# Conceptual Review Agenda

Schedule for 06/24/13 to 06/24/13

# Terre Vida 2 Multifamily

CONCEPTUAL REVIEW:  
APPLICATION

CONCEPTUAL SITE PLAN 3

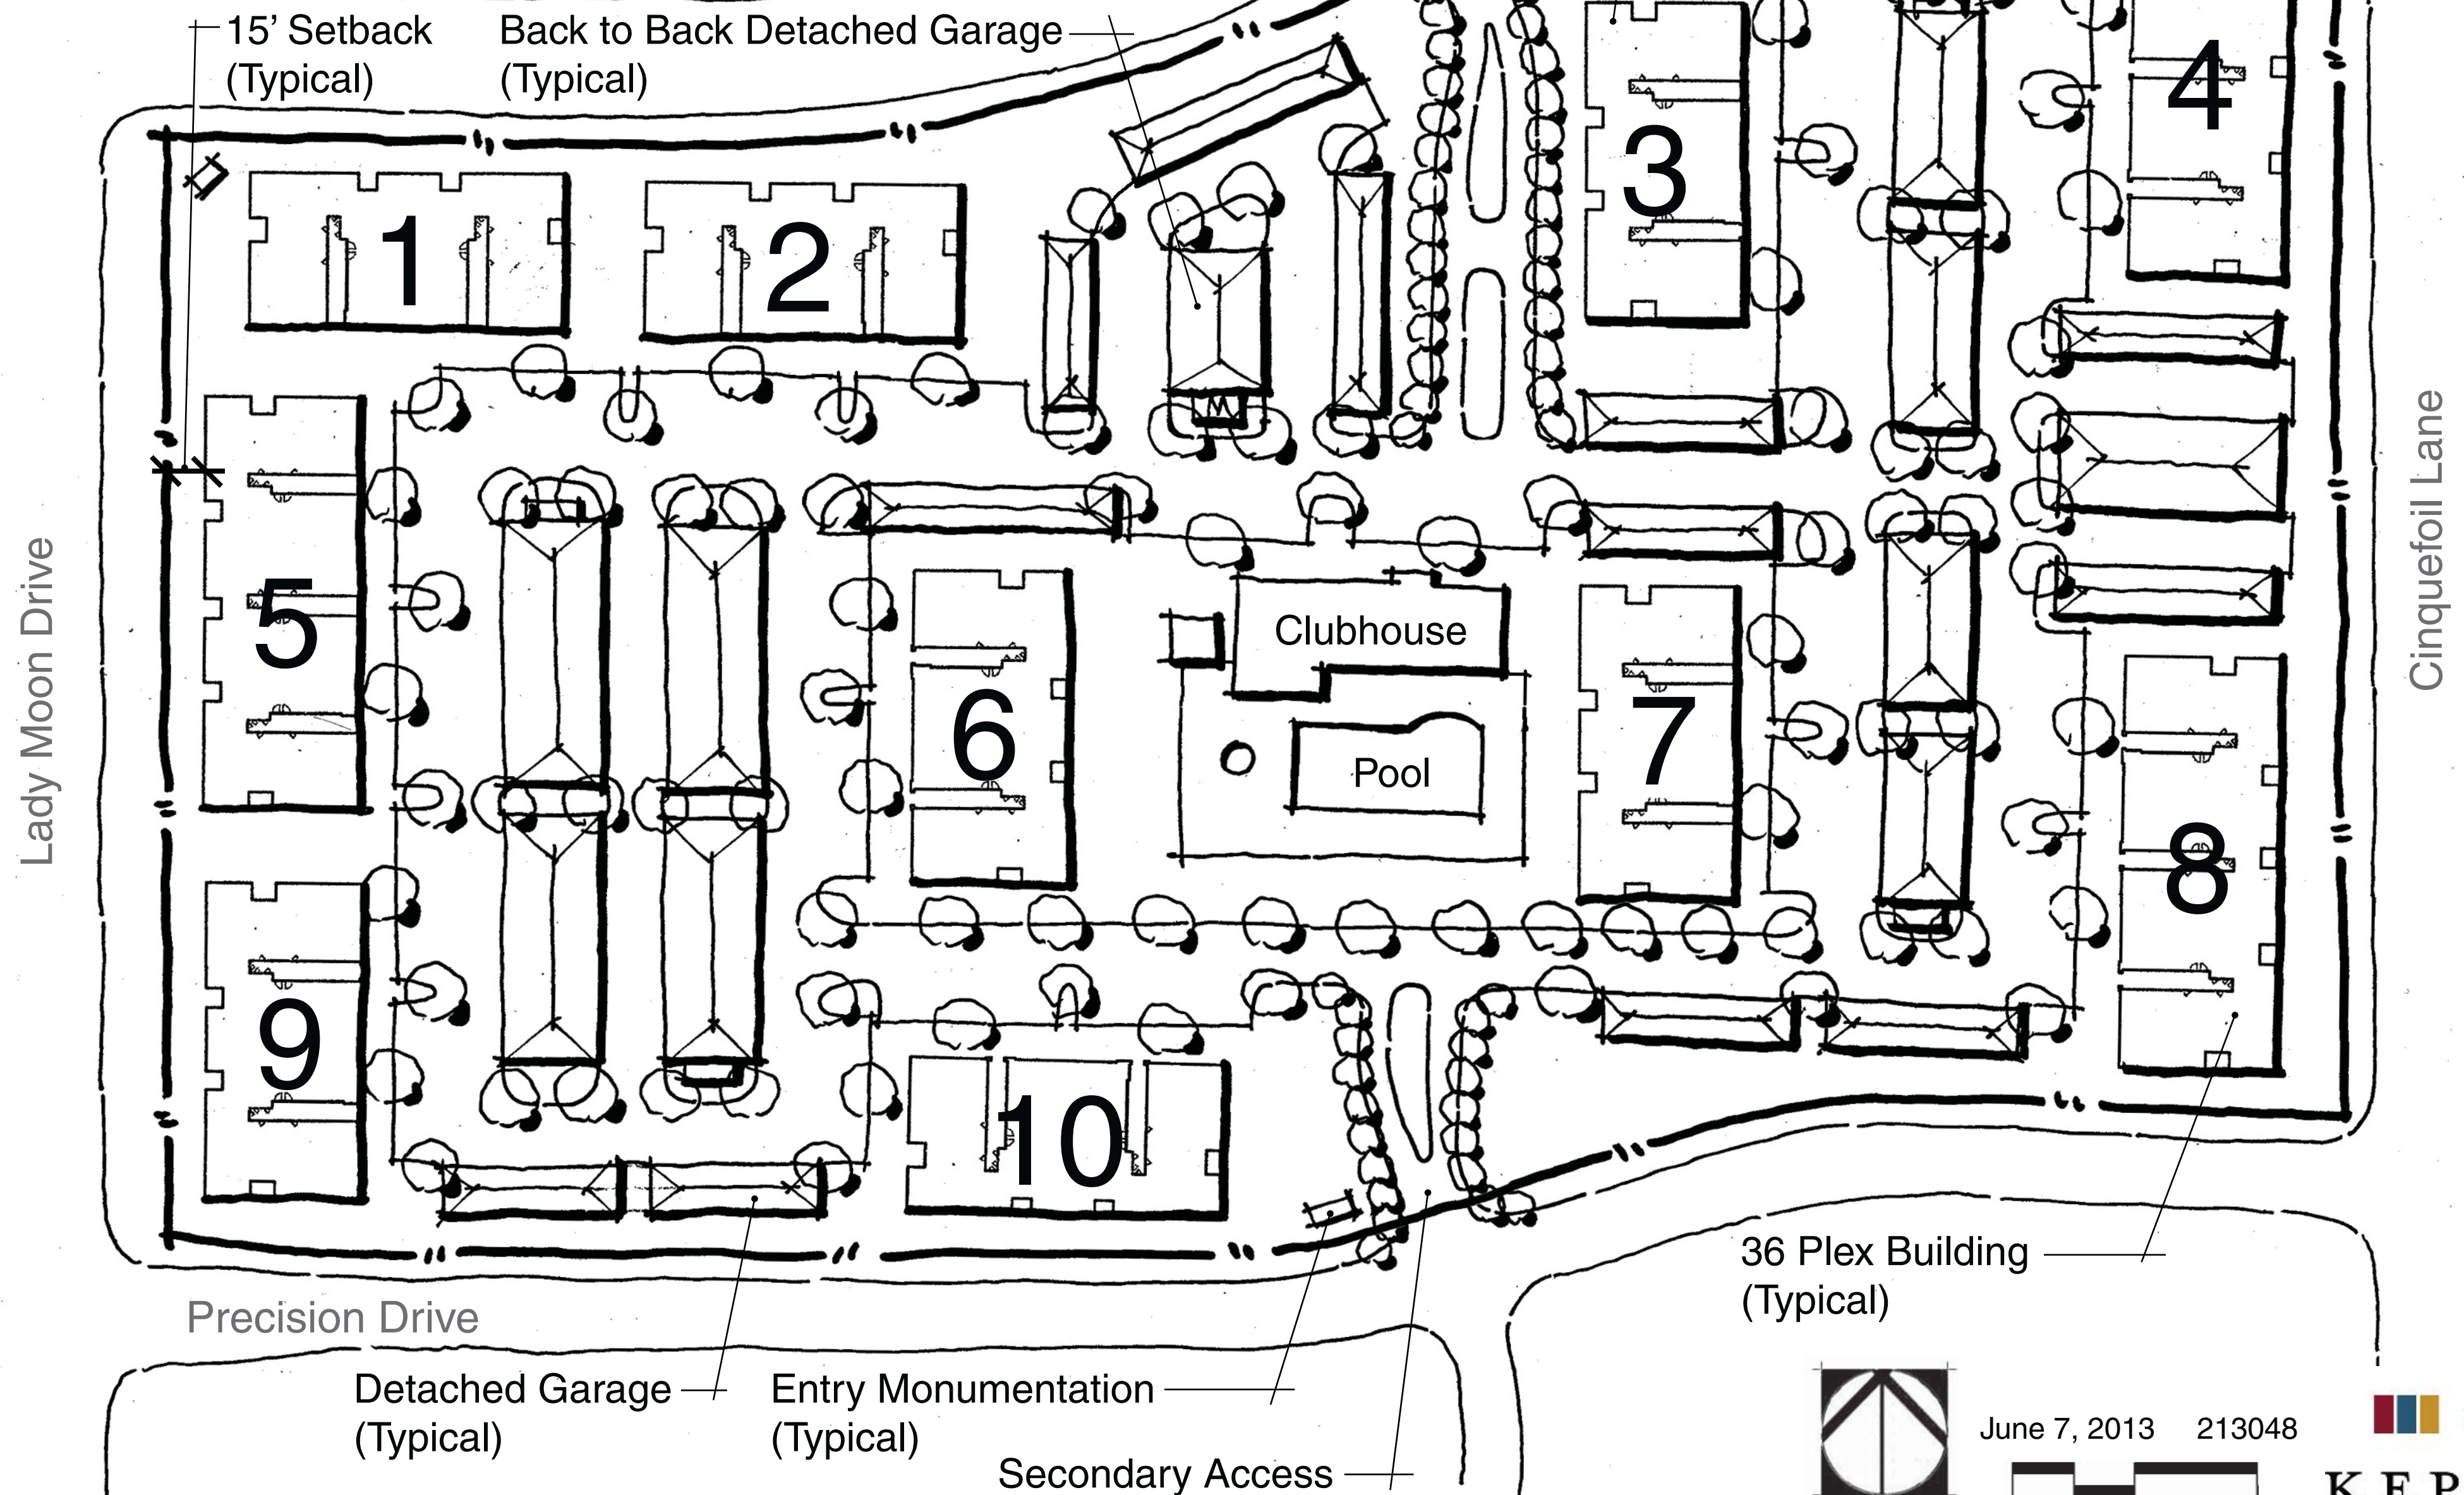
The four perimeter public streets offer an excellent opportunity to comply with this standard by providing entrances facing the street, with connecting walkways to the public sidewalk. These entrances must be prominent with entry features that project off the vertical wall plane. Please note that entry features, with secondary roofs and covered doorways, may also contribute to compliance with Section 3.8.30(F)(2) - Variation Among Repeated Buildings; 3.8.30(F)(4) - Entrances; 3.8.30(F)(5) - Roofs; 3.8.30(F)(6) - Facades and Walls.

3. There are several instances where the backs of the garages face a public street. Please note that Section 3.5.2(F) requires that these elevations be upgraded. Also, the Landscape Plan should emphasize a generous amount of plant material to screen these areas of low visual interest.

5. On Terra Vida One, the large stormwater detention pond doubles as passive open space for the benefit of the residents and is also an ideal location for dog walking. Terra Vida Two, however, does not include a stormwater detention basin. You are encouraged, therefore, to provide ample areas of passive open space to allow for passive enjoyment of the residents.
